Access Compliance Report Public Rights-of-Way (Curb Ramps)

Intersection ID: 11514 Main Street: E_20TH_ST Cross Street: N_MCDOWELL_ST Location: E

ADA ID: B419EBB0106B Ramp Type: PerpDiag Initial Pass/Fail: Fail Overall Compliance: No Severity Score: 48.75

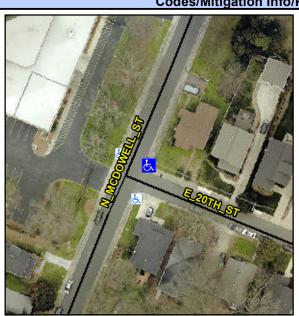
Not Found, R304.5.1, R304.2.2, R304.5.3

Comp	Compliance Description		Compliance		Description	Data
N/A	Ramp Length (in)	52.0	No	Ramp	Slope (%)	9.2
No	Ramp Width (in)	27.5	No	Ramp	XSlope (%)	4.5
N/A	Flare Type LT	N/A	N/A	Flare	Type RT	N/A
N/A	Flare Slope LT (%)	N/A	N/A	Flare	Slope RT (%)	N/A
N/A	Flare Traversable LT?	N/A	N/A	Flare	Traversable RT?	N/A
N/A	Landing Length (in)	N/A	N/A	DWS	Provided?	N/A
N/A	Landing Width (in)	N/A	N/A	DWS	Contrast?	N/A
N/A	Landing Slope (%)	N/A	N/A	DWS	Length (in)	N/A
N/A	Landing X Slope (%)	N/A	N/A	DWS	Full Width?	N/A
N/A	Landing Curb? (Y/N)	N/A	N/A	DWS	Offset (in)	N/A
N/A	Shared Landing?	N/A				
N/A	Gutter Ponding?	N/A	N/A	Gutte	r Slope (%)	N/A
N/A	Gutter Lip Ht (in)	0.5	N/A	Gutte	r X Slope (%)	N/A
N/A	Painted X Walk1?	No	N/A	Paint	ed X Walk2?	No
	X Walk 1 Direction	To NW		X Wa	lk 2 Direction	To SW
N/A	X Walk 1 Width (in)	N/A	N/A	X Wa	lk 2 Width (in)	N/A
	X Walk 1 Slope (%)	1.4		X Wa	lk 2 Slope (%)	1.4
	X Walk 1 X Slope (%)	0.1		X Wa	lk 2 X Slope (%)	7.1

Remove & Replace Curb Ramp With Two New Directional Ramps or Equivalent.
